Board Report

Board Decision	On 8/10/21, the ERCOT Board voted to recommend approval of NOGRR210 as recommended by TAC in the 6/23/21 TAC Report.

NOGRR Number	<u>210</u>	NOGRR Title	Related to NPRR1005, Clarify Definition of Point of Interconnection (POI) and Add Definition Point of Interconnection Bus (POIB)
Impact Analysis Date	February 26, 2020		
Estimated Cost/Budgetary Impact	None.		
Estimated Time Requirements	No project required. This Nodal Operating Guide Revision Request (NOGRR) can take effect upon implementation of Nodal Protocol Revision Request (NPRR) 1005, Clarify Definition of Point of Interconnection (POI) and Add Definition Point of Interconnection Bus (POIB).		
ERCOT Staffing Impacts (across all areas)	Ongoing Requirements: No impacts to ERCOT staffing.		
ERCOT Computer System Impacts	No impacts to ERCOT computer systems.		
ERCOT Business Function Impacts	No impacts to ERCOT business functions.		
Grid Operations & Practices Impacts	No impacts to ERCOT grid operations and practices.

Figure 1: Default Voltage Ride-Through Boundaries for IRRs

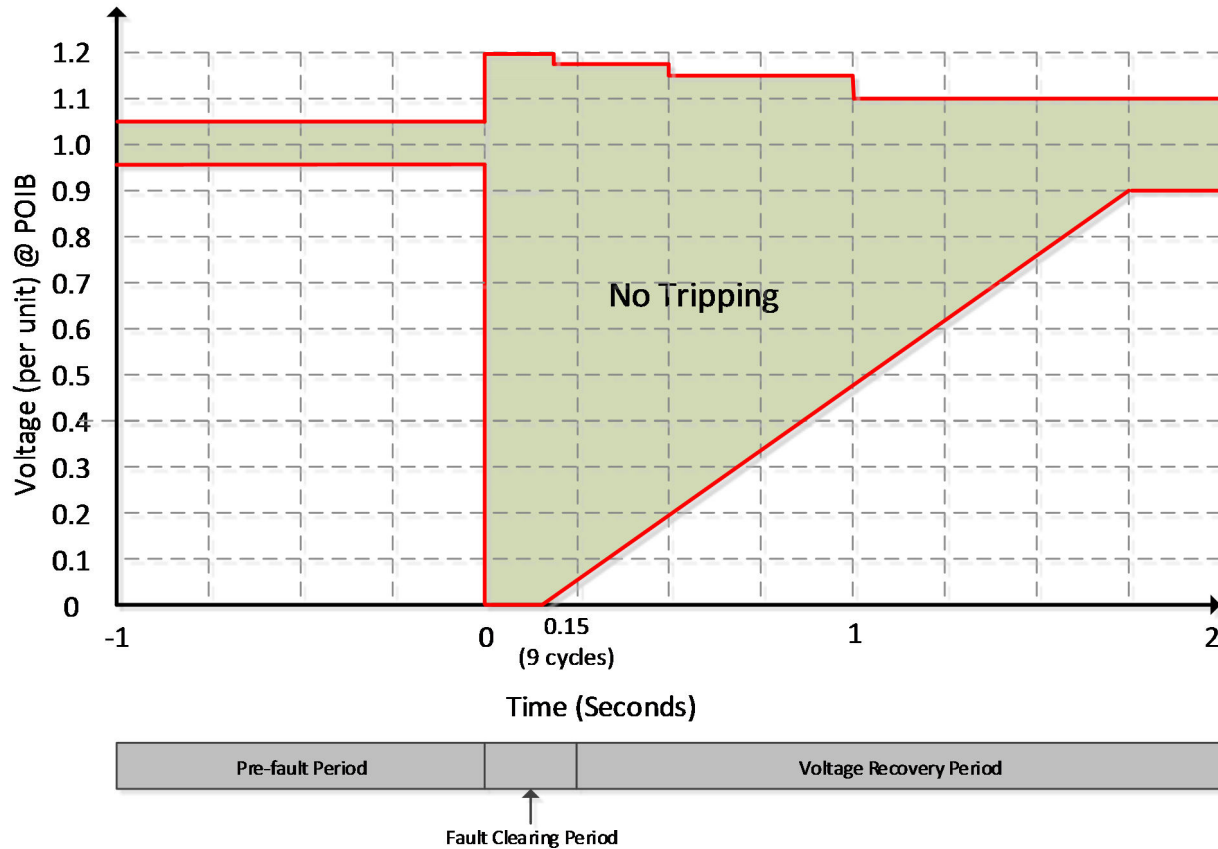
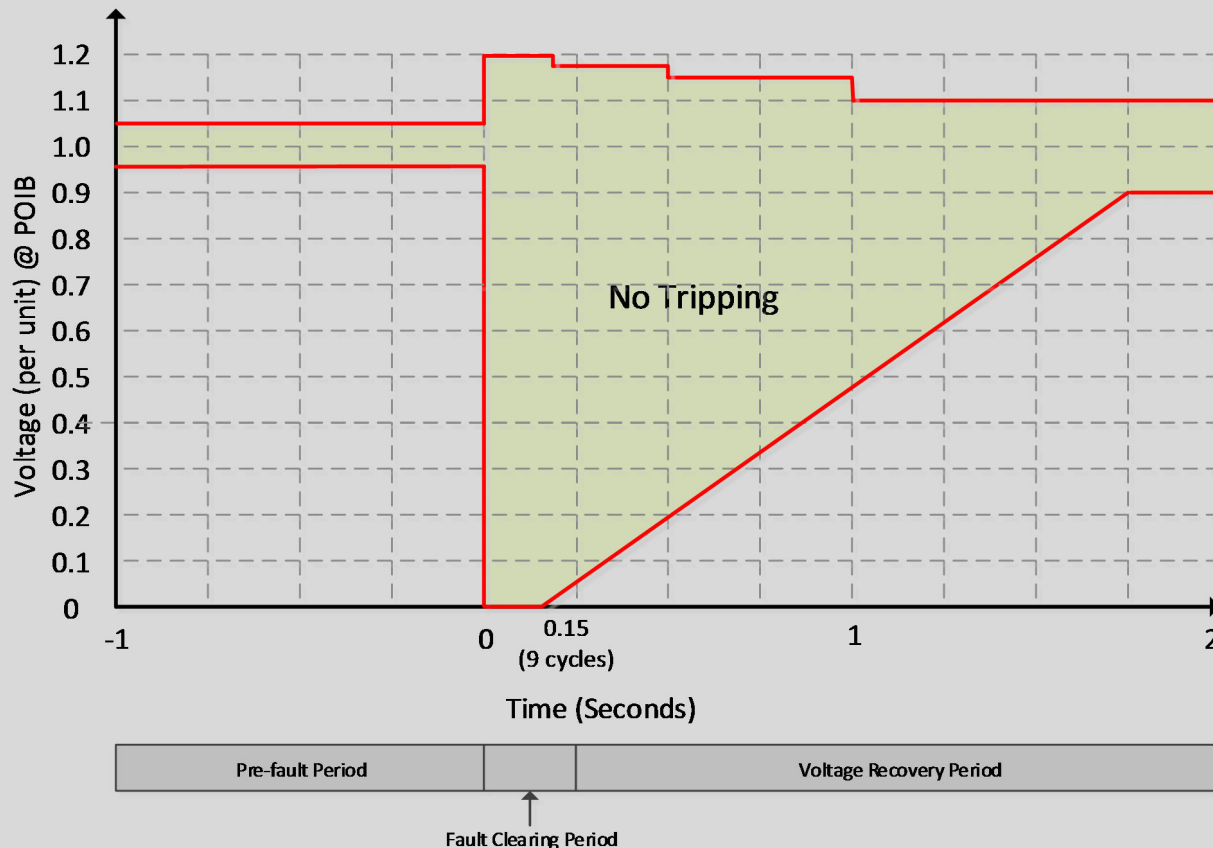
[NOGRR204 and NOGRR212: Replace applicable portions of Section 2.9.1 above with the following upon system implementation of NPRR989 or NPRR1016, respectively:]

- (3) Each IRR or ESR is required to set its voltage relays to remain in service for at least 0.15 seconds during all transmission faults and to allow the system to recover as illustrated in Figure 1, Default Voltage Ride-Through Boundaries for IRRs and ESRs, below. Recovery time to 90% of per unit voltage should be within 1.75 seconds. Faults on individual phases with delayed clearing (zone 2) may result in phase voltages outside this boundary but if the phase voltages remain inside this boundary, then Resource voltage relays are required to be set to remain connected and recover as illustrated in Figure 1.

- (5) Each IRR or ESR shall set its voltage relays to remain interconnected to the ERCOT System during the following high-voltage conditions, as illustrated in Figure 1: any per-unit voltage equal to or greater than 1.175 but less than 1.2 for up to 0.2 seconds, any per-unit voltage equal to or greater than 1.15 but less than 1.175 per unit voltage for up to 0.5 seconds, and any per-unit voltage equal to or greater than 1.1 but less than 1.15 for up to 1.0 seconds. The indicated voltages are measured at the POI.
